Change of use from office to single open plan residential unit. Internal fit out to include kitchen and minimal internal walls. At 104 Constitution Street Edinburgh EH6 6AW

## Application No: 20/05447/FUL

## DECISION NOTICE

## **Report of Handling**

Excerpt from drawing 251-41000 - Existing Floor Build Up

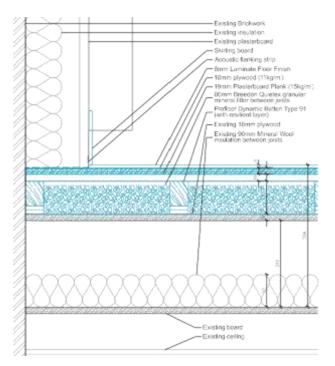
To address concerns regarding airbourne noise transmission from the restaurant and retail units below, we now include proposals to upgrade the floor as shown in the marked-up drawings and detailed in drawings 251-41000 (exisitng) and 251-41001 (proposed), excerpts of which are shown here.

This upgrade will cover the entire floor area that sits above the retail units and pend.

Excerpt from drawing 251-41001 - Proposed Floor Build Up

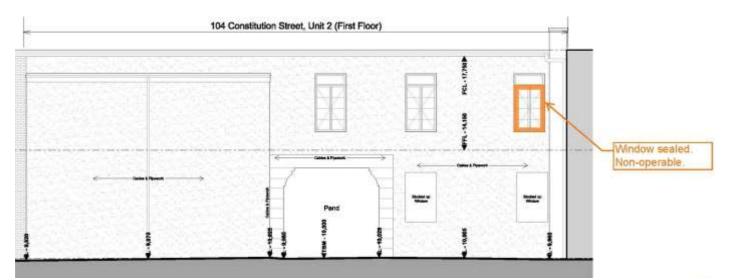
To eliminate the worst of the external plant noise, we propose to seal the window closest to the chimney to prevent it from opening. This will ensure noise levels within the proposed dwelling are below the standards set out in the revised Noise Impact Assessment.

Figure 1 - 19/02664/AMC Noise Mitigation (closed windows on yellow elevations).

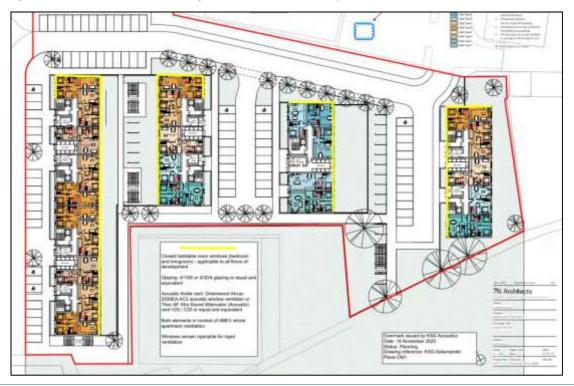
- 11. Notwithstanding the fact that the Applicant team considers that it is inappropriate to determine the application now on decisions which may be made in the future, it is clear that closed window attenuation is a commonly used method of mitigation against external noise in residential properties. For example, application reference 19/02664/AMC for the 'Approval of Matters Specified in Conditions 1 and 17 of 16/03356/PPP for Phase 6 and 7 of the approved masterplan', at Former 9 21 Salamander Place, Edinburgh. This application comprised four apartment blocks consisting of 151 flats in total. Closed window attenuation with trickle ventilation (windows openable for rapid ventilation), was accepted on the northern and east / west elevations of all four apartment blocks to all habitable room windows (bedrooms and living rooms) on all floors of the development, as demonstrated on the plan below (yellow line indicating closed windows).

- 12. This mitigation was required due to the existing industrial and commercial noise sources to the immediate north of that site at Former 9 21 Salamander Place, and has been granted consent by CEC. A consistent approach is requested.
